H11572

DESCRIPTIVE REPORT

Descriptive Report to Accompany Hydrographic Survey H11572

Project OPR-O119-FA-07
Ernest Sound and Eastern Passage, Alaska

Figure 5: An overview of H11572 with areas displaying "gaps" appearing in finalized surface

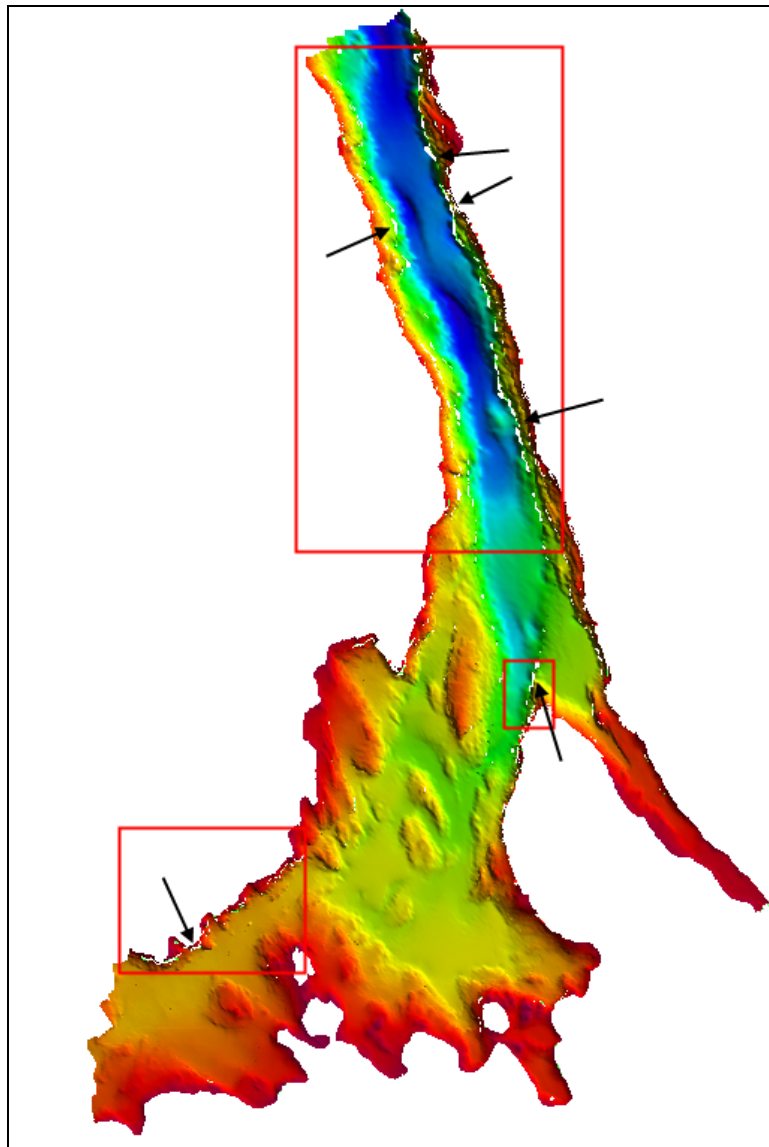
⁷ Concur with clarification. Holidays not addressed in the DR were found by the survey reviewer. The reviewer reformatted the grid resolutions and depth thresholds to represent the highest resolution the data would support and to close gaps between finalized surfaces on steep slopes. See also Comments notes 4 and 5 in H11572_Survey_Review_Checklist filed with survey records.

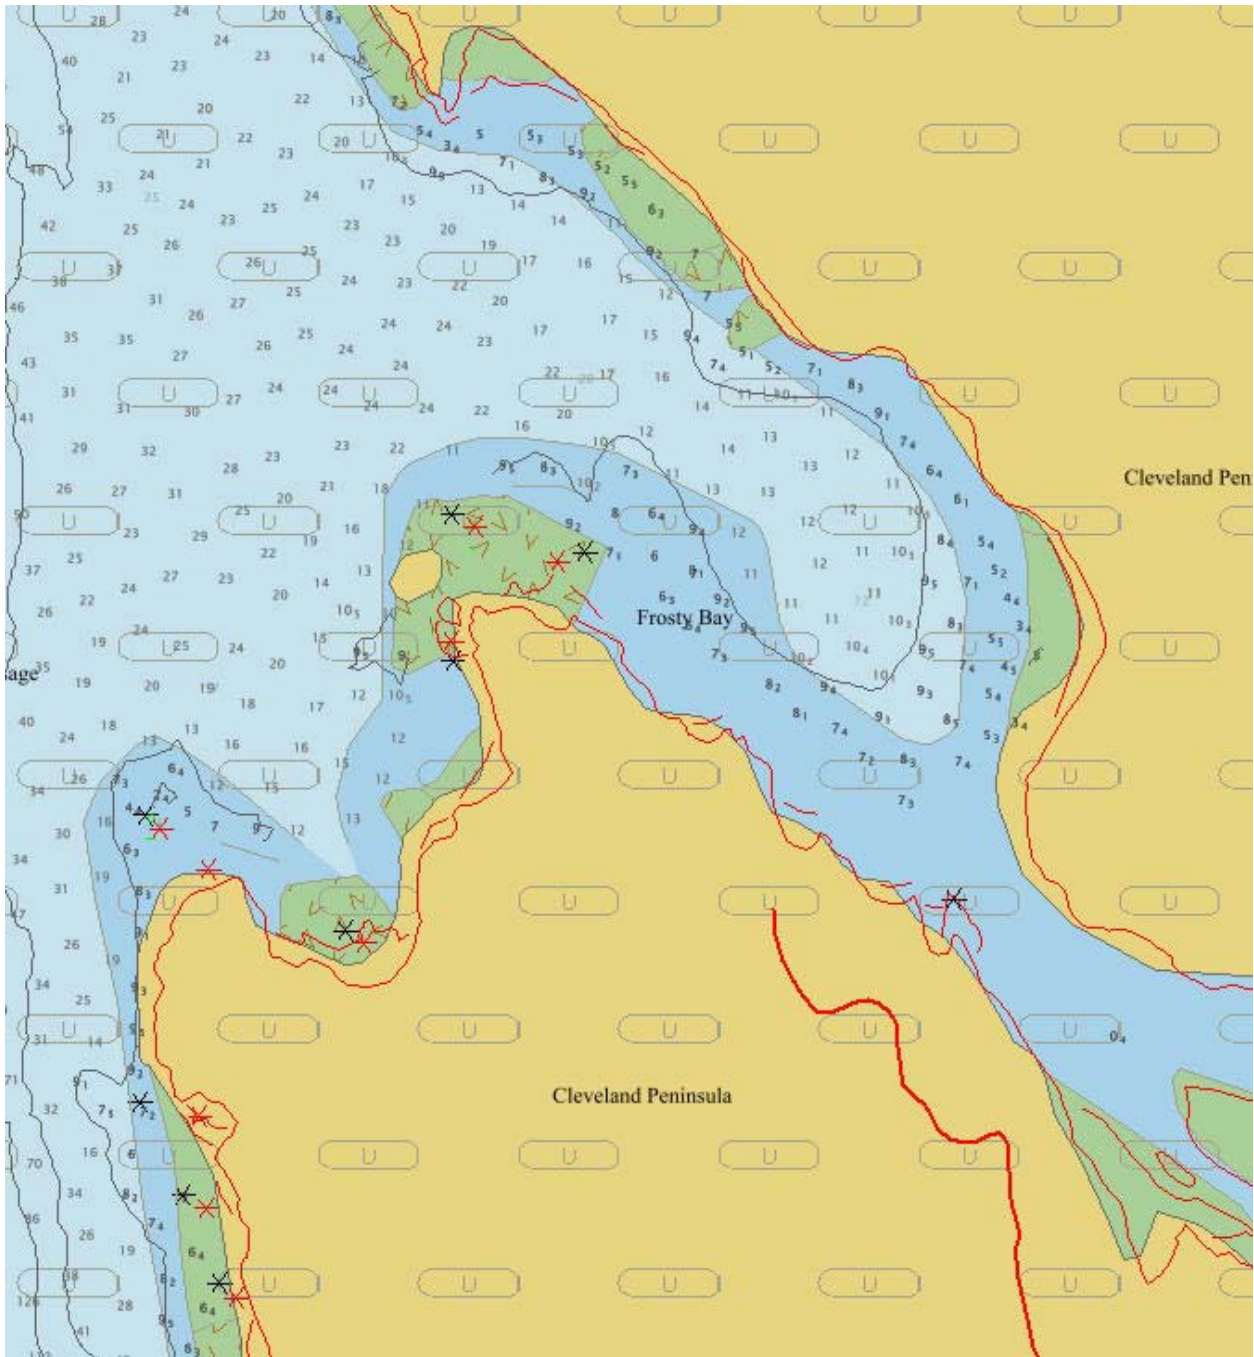
This is one of the areas in H11569 where the GC has not been applied to ENC US4AK3OM or chart 17385.

The GC (Composite Source) is in red. There are plenty of places where soundings/DEPARE overlap with ledges.

We looked at the GC application and realized that it was applied to the raster with a southeastern shift of about 0.33 mm. This error was reproduced on the ENC.

I recommend you compile the hydro in it's exact geographic position with an understanding that the GC horizontal accuracy is correct, but our ENC/Raster may not be horizontally accurate. It would not help us to apply the GC shoreline in the HCell. If you need more help describing the error so you can make a note of it, I'm happy to discuss it.
